JAFP-14-0102
August 21, 2014

Subject: Response to Request for Additional Information (RAI) Associated with Near-Term Task Force (NTTF) Recommendation 2.1, Seismic Hazard and Screening Report
James A. FitzPatrick Nuclear Power Plant
Docket No. 50-333
License No. DPR-059

**RAI Responses
(7 Pages)**

Attachment 1 – JAF Turbine Building Complex Structural Model Developed for Seismic Design

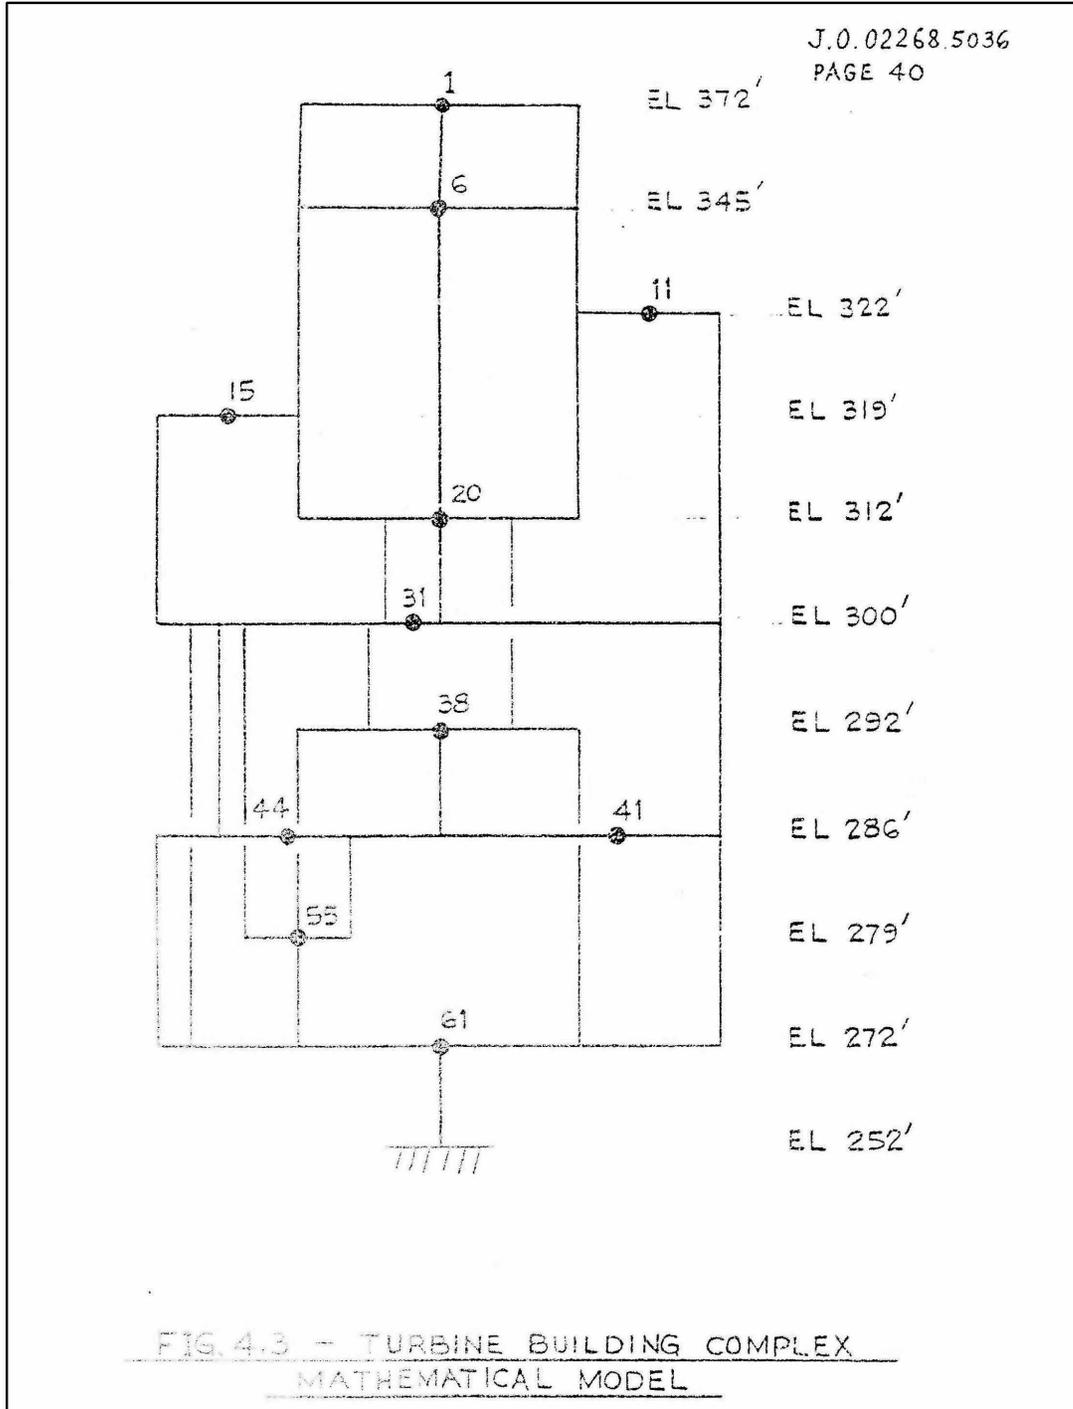
Appendix B of the seismic hazard screening report states that criteria in Table 2-3 from EPRI NP-6041 which is intended for use with structures designed as Seismic Category I structures was applied to the Seismic Category II turbine building as a basis for screening out the turbine building from the seismic margin analysis. Justifications provided for application of EPRI NP-6041 Table 2-3 in this manner include the use of lower damping values and other constraints used in the Operating Basis Earthquake (OBE) analysis of the turbine building.

- a. In the IPEEE, EPRI NP-6041 screening criteria intended for Seismic Category I structures was applied to the Seismic Category II turbine building. The turbine building, as a Seismic Category II structure, could have been designed using local building codes. The seismic performance of buildings designed using local building codes may differ significantly compared to buildings designed in accordance with NRC guidance for Seismic Category I structures. Due to these potential differences, similar design peak ground acceleration is not considered a sufficient justification for screening. Provide additional explanation to justify the application of the EPRI NP-6041 screening criteria intended for Seismic Category I structures as applied to the Seismic Category II turbine building.

- b. It is unclear in Appendix B what is meant by "constraints" used in the OBE analysis. Provide additional clarification and explanation on what is meant by constraints used in the OBE analysis and how that affects the design of the turbine building.

- c. The damping value used in the OBE analysis was not clearly indicated. Describe what was the damping value used in the OBE analysis and why is it appropriate for your site.

- a. The Turbine Building Complex at the James A Fitzpatrick Nuclear Power Plant (JAF) includes the Turbine Building, Administration Building, Radwaste Building, Screenwell-Pump House and Emergency Diesel Generator building. All of these buildings are structurally connected and, thus, a single structural model was developed as part of the seismic design basis. Parts of this complex are designated as Class I structures; the balance are Class II structures. As stated in Section 12.4.6.3 of the JAF Updated Final Safety Analysis Report (UFSAR):

State-of-the-art seismic analysis for that time frame was performed by developing a horizontal and a decoupled vertical mathematical model. The horizontal model is depicted in Attachment 1, and the lumped masses depict all of the structures comprising the turbine building complex (both Class I and Class II).

The UFSAR specifically notes that for the Class II structures within the Turbine Building Complex, both the OBE and Design Basis Earthquake (DBE) were evaluated using this combined model. However, due to more conservative characterizations of damping and allowable stresses for the OBE case, DBE level earthquake loading did not govern the design over the OBE level:
